State of Alaska
Department of Fish and Game
Sportfish Division

Nomination Form
Anadromous Waters Catalog

Anadromous Waters Catalog Number of Waterway 108-30-10200

108-30-10200**CORRECTION****Water body name:****Survey date:** 7/15/2013**Water body number:** 108-30-10200**Species & Lifestage:** CHp, COp, Pp, DVp**Watershed:** Ohmer Creek-Frontal Sumner Strait**MTR:** C062S080E **Quad:** Petersburg C-3

Figure 2.—Tess Quinn looking up the chute.

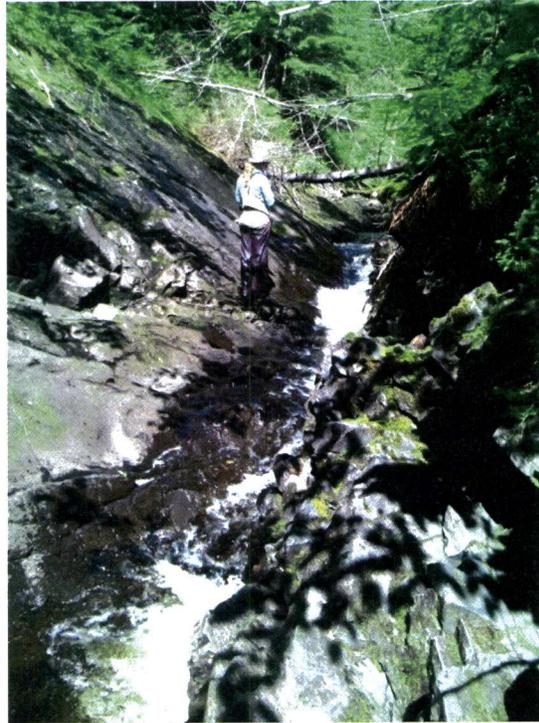
Findings: We surveyed stream 108-30-10200 and caught coho salmon using an electrofishing unit (Table 1). The stream flows from Sumner Mountain and is crossed by Woodpecker Cove Road before entering into Sumner Strait. The stream has a pool at the base of a bedrock chute (Figure 1). We ended the survey a ways up chute, the chute would be a barrier at high and low flows (Figure 2).

Figure 3.-108-30-10200 route correction map.

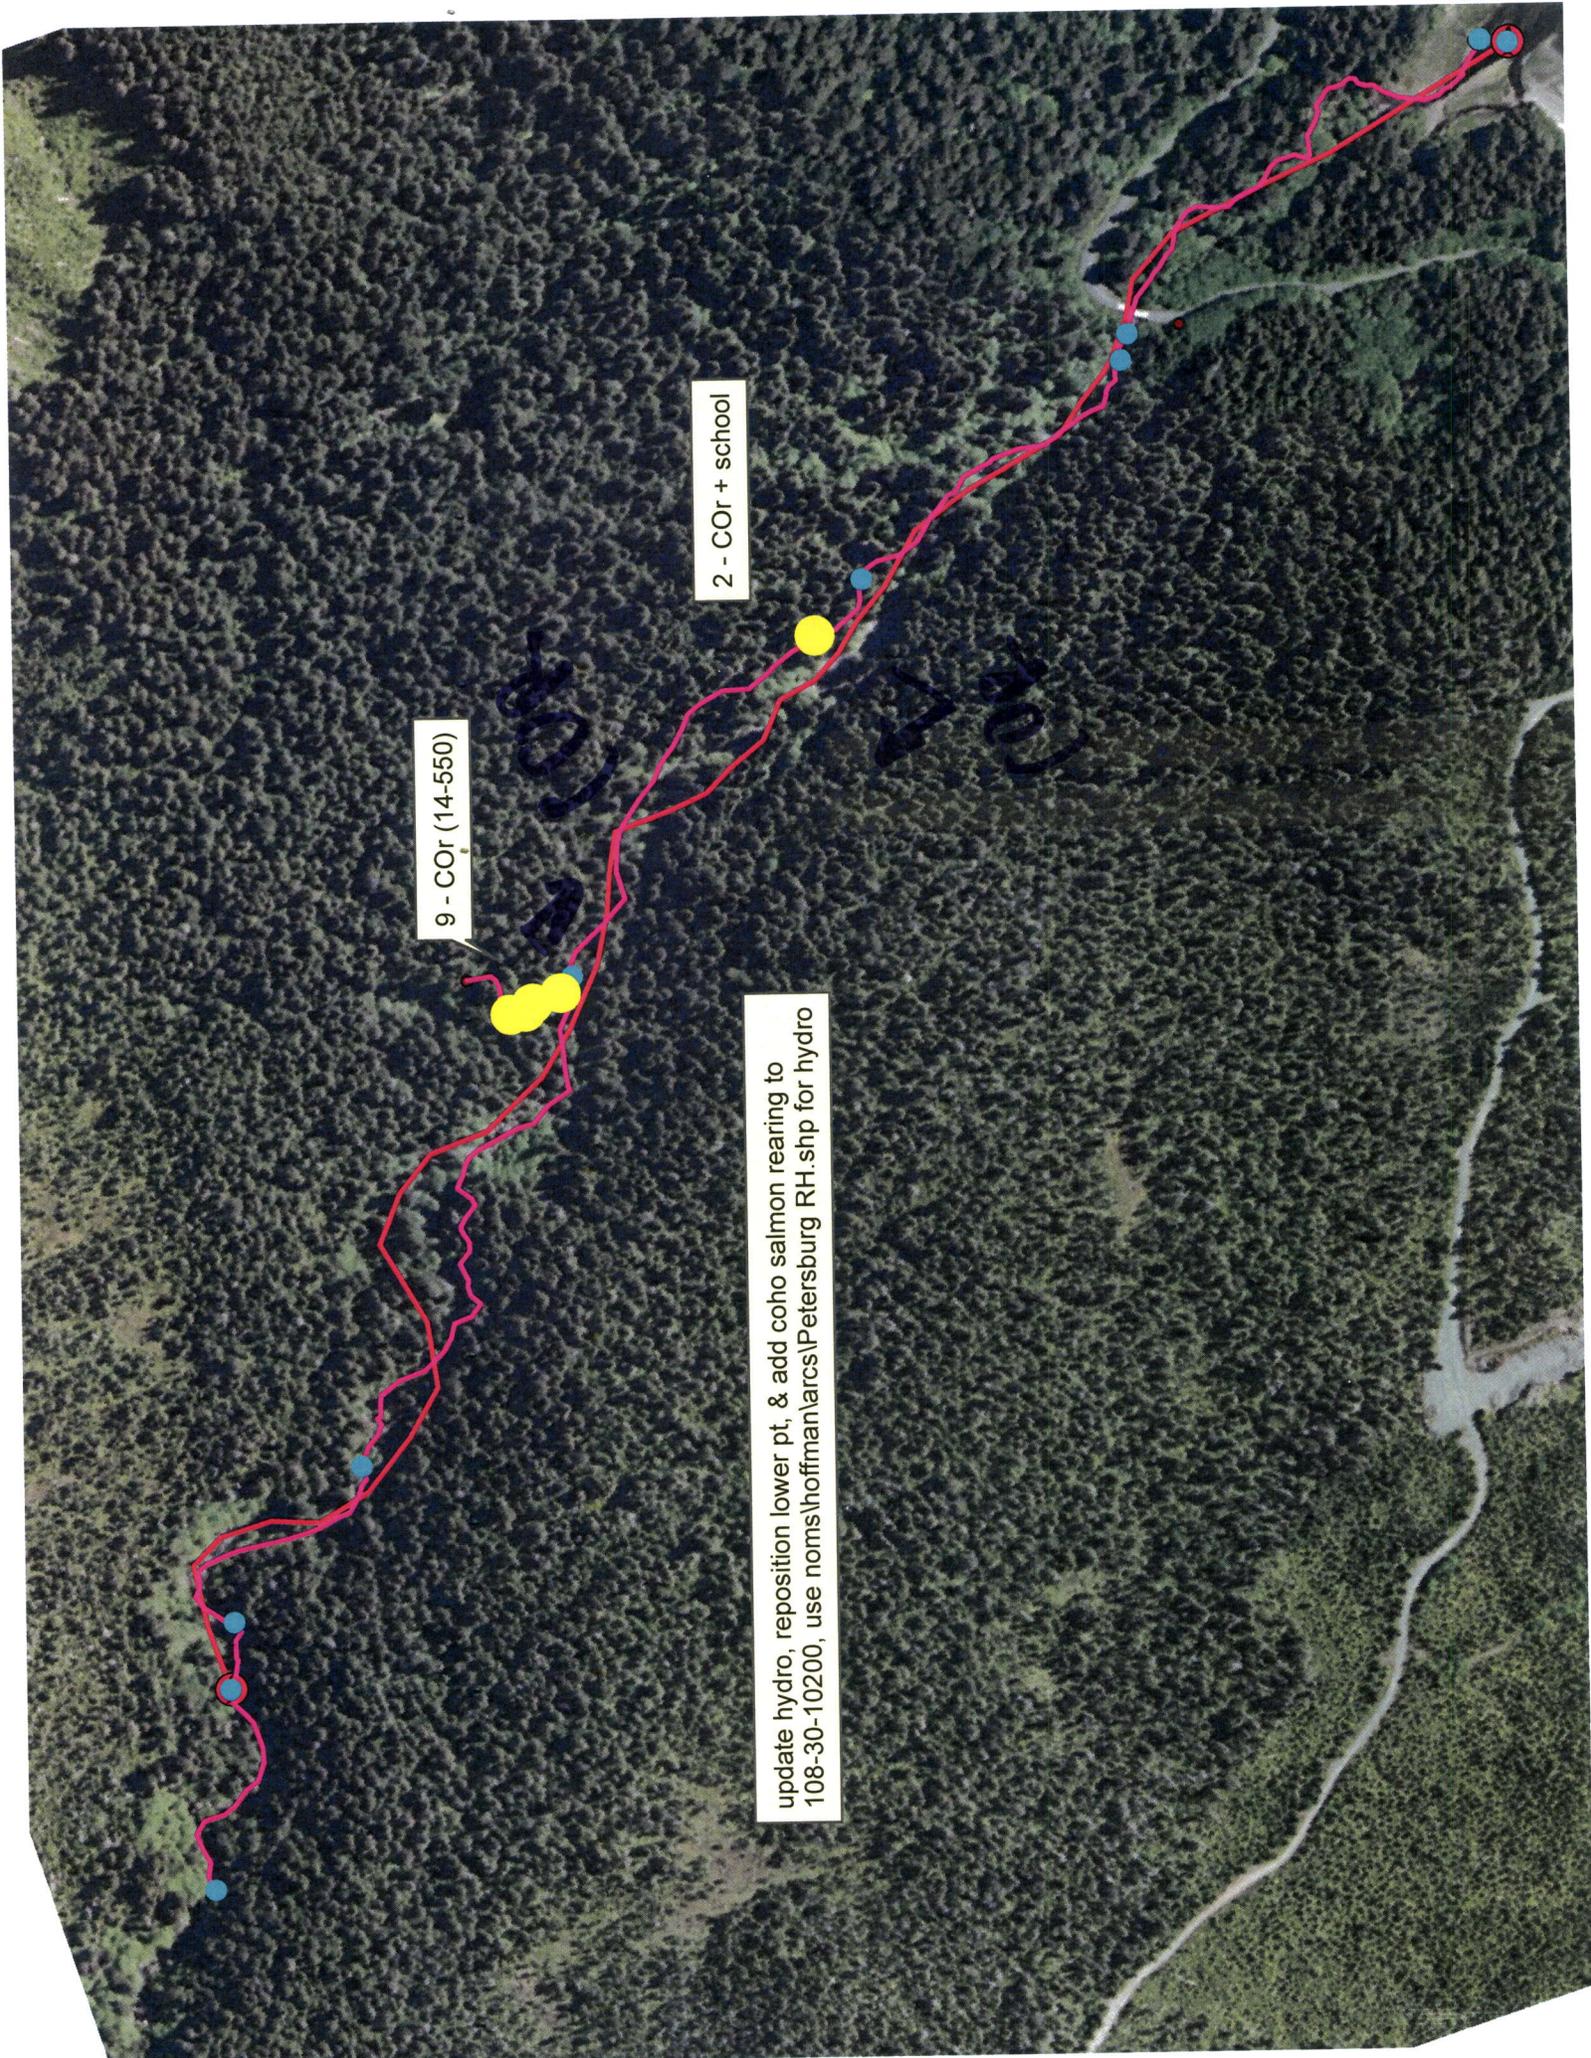
Recommendations: Correct the current route in AWC.

update hydro, reposition lower pt, & add coho salmon rearing to 108-30-10200, use noms\hoffman\arcs\Petersburg RH.shp for hydro
